CITY OF ALBUQUERQUE

RE: **Lomas Carwash Expansion**
9935 Lomas NE
Grading Plan Stamp Date: 3/27/19
Drainage Report Stamp Date: 3/27/19
Drainage File: J20D003

From: Peterson, Dana M. [dpeterson@cabq.gov]
Sent: Tuesday, March 26, 2019 4:17 PM
To: 'David Soule'
Subject: RE: LOMAS CAR WASH

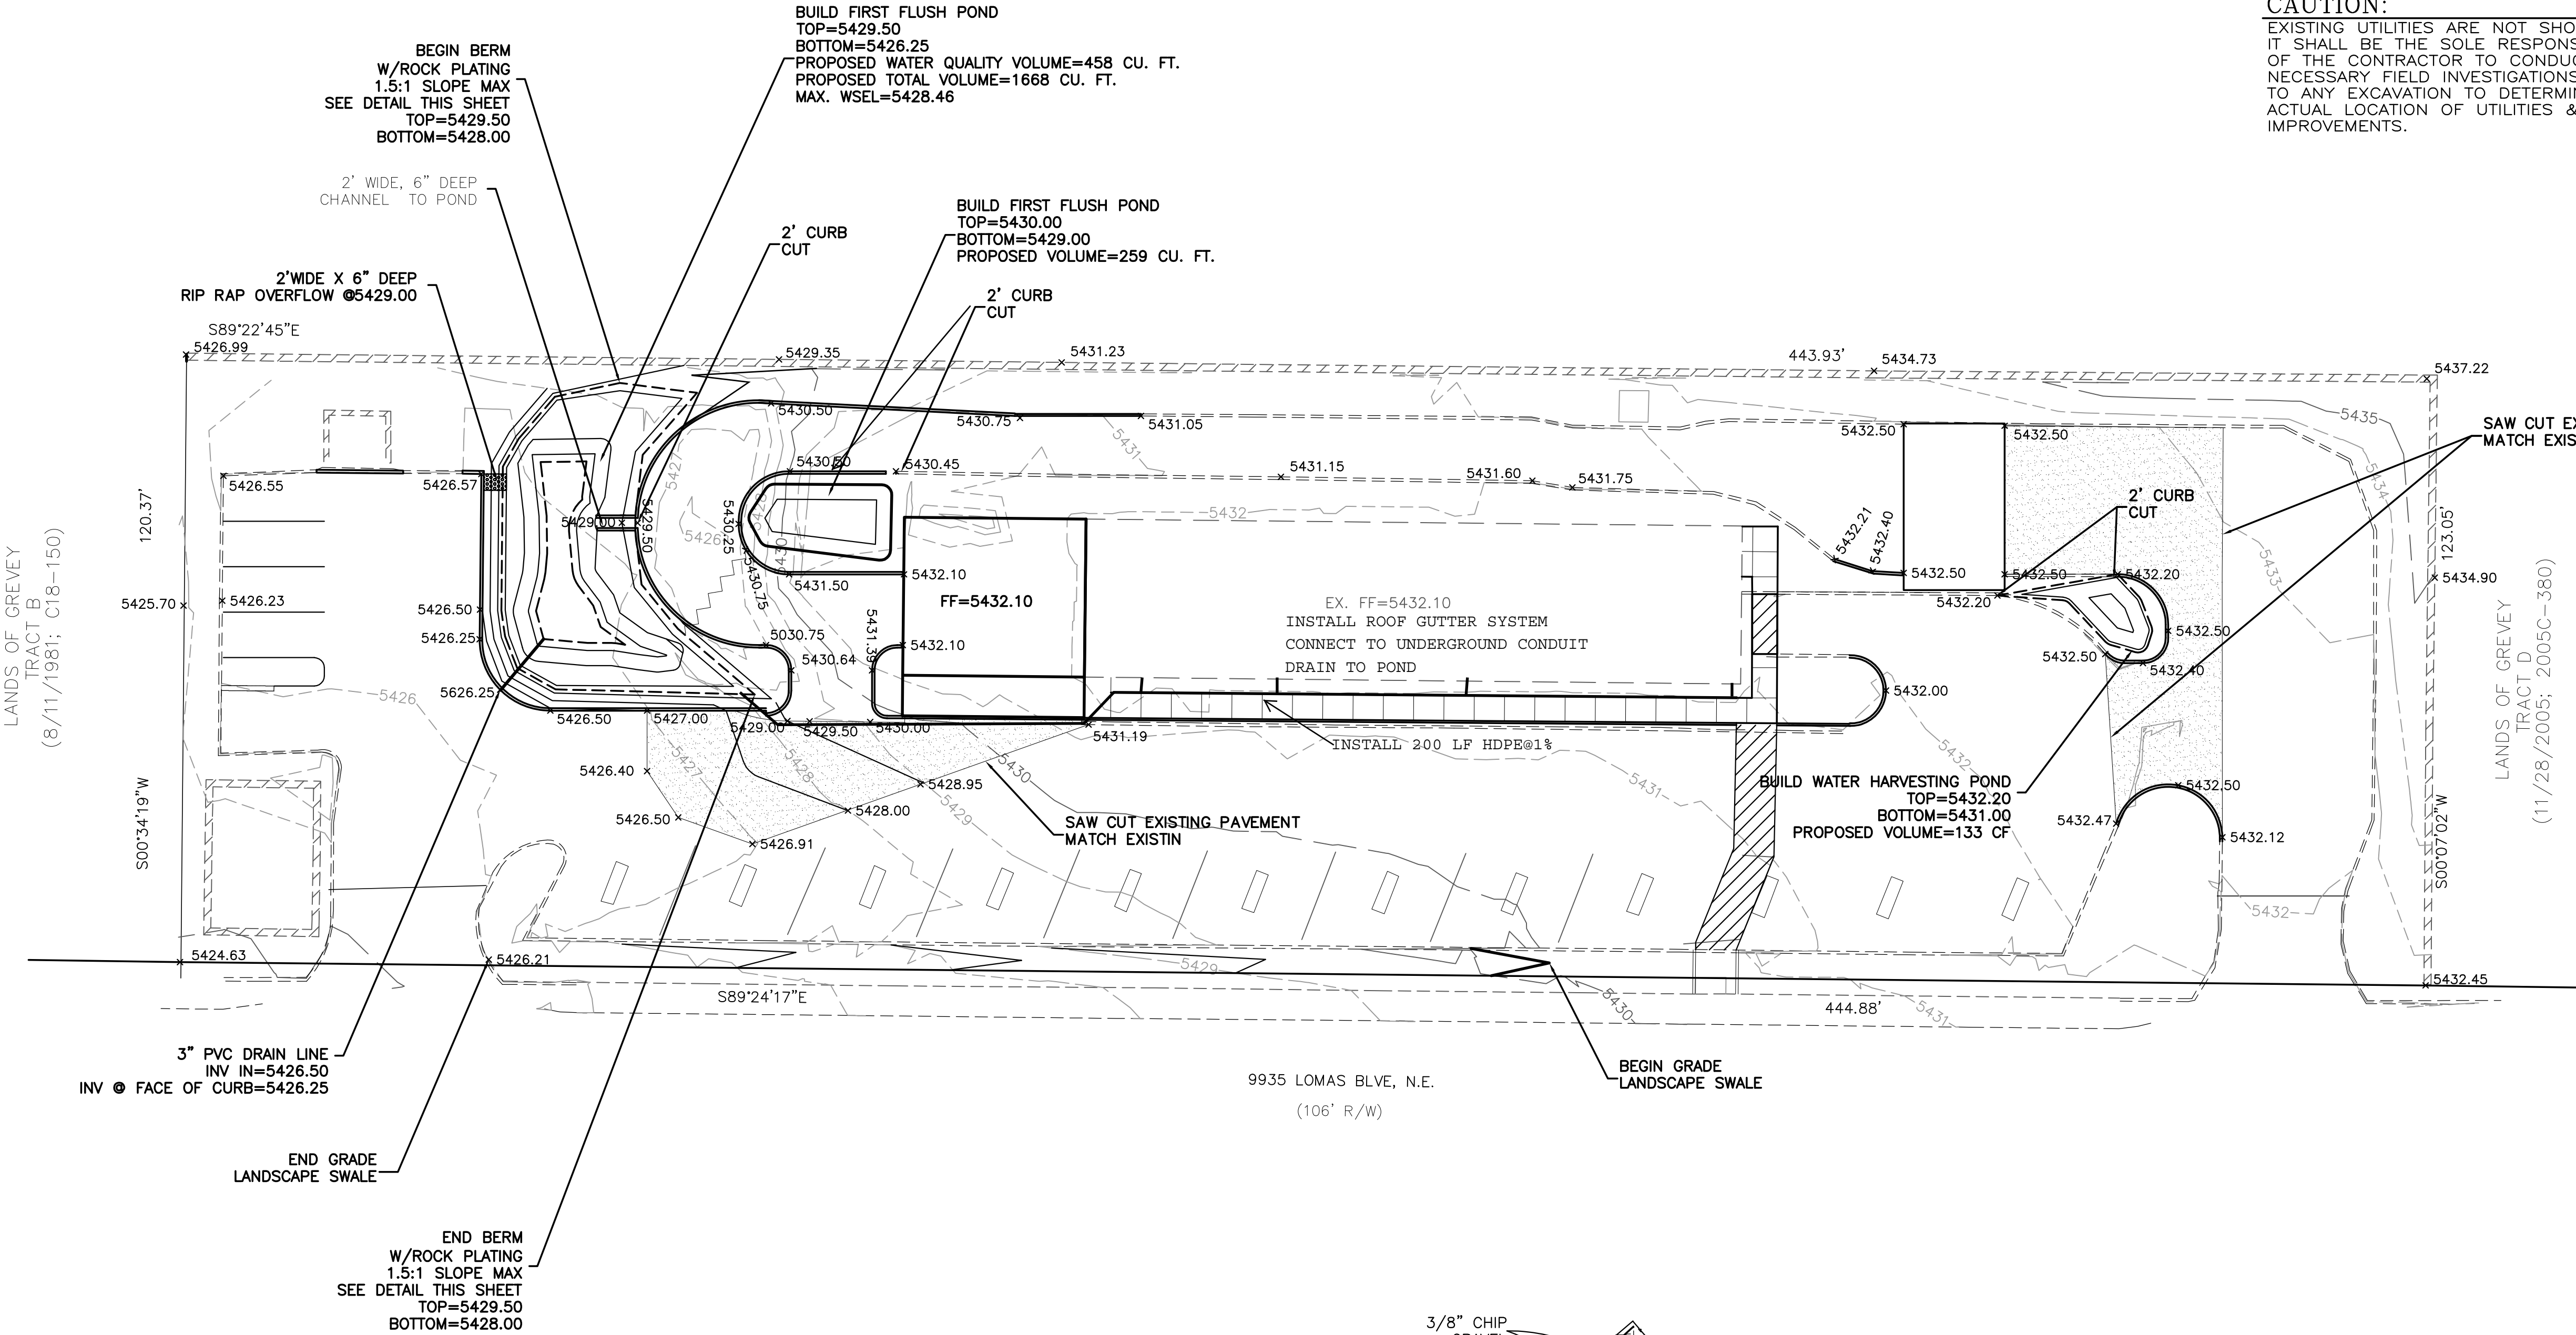
I need a copy of the drainage report with this (.pdf). Also, look at the south end of the berm- it's still at 28.5' and doesn't tie-in to the 29' contour; please correct and resend an .pdf.

The clients asked me to try to walk this thru, I said we don't do that but I would send email to the reviewer directly. The only change was raising the berm 1' and adding an overflow, the raising caused slope to exceed 3:1 so I added rock plating. Thank you

Based on the submittal received on 3/28/19, the grading plan and drainage report are approved for Grading Permit and Building Permit.
